PLANNING AND ACCESS COMMITTEE

| APPLICATION NUMBER: | 2018/0210/DET |
| LOCATION: | Loch Lomond Arms Hotel Luss Alexandria G83 8NY |
| PROPOSAL: | Erection of hotel accommodation block. Erection of biomass plant (retrospective) |

Figure 7. Proposed Elevations Biomass Plant

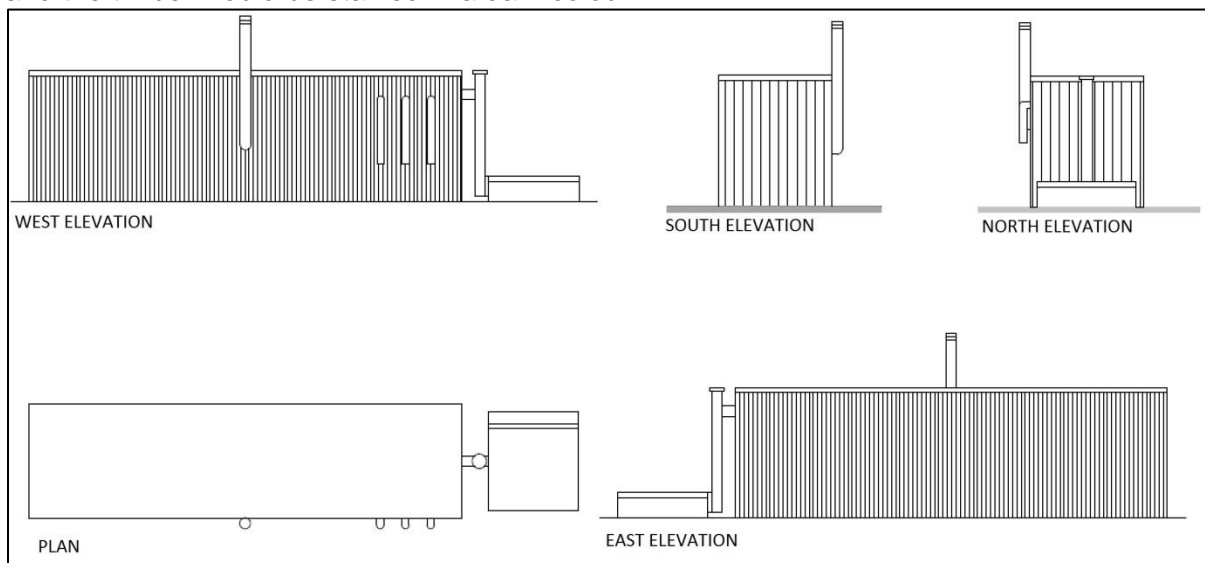
- 7.9 The proposed biomass plant would be relocated to the north east corner of the site. It is currently finished in vertical timber cladding which has faded to grey and there are large silver flues on the west and north elevation. It is recommended that to ensure the biomass plant is visually recessive the colour of the timber cladding and matt flues are specified through imposition of a planning condition.

- e) Detailed drawings of the proposed external walkway including annotated details of the proposed materials;
 - f) The colour/treatment/finishes of the timber and flues on the biomass plant;
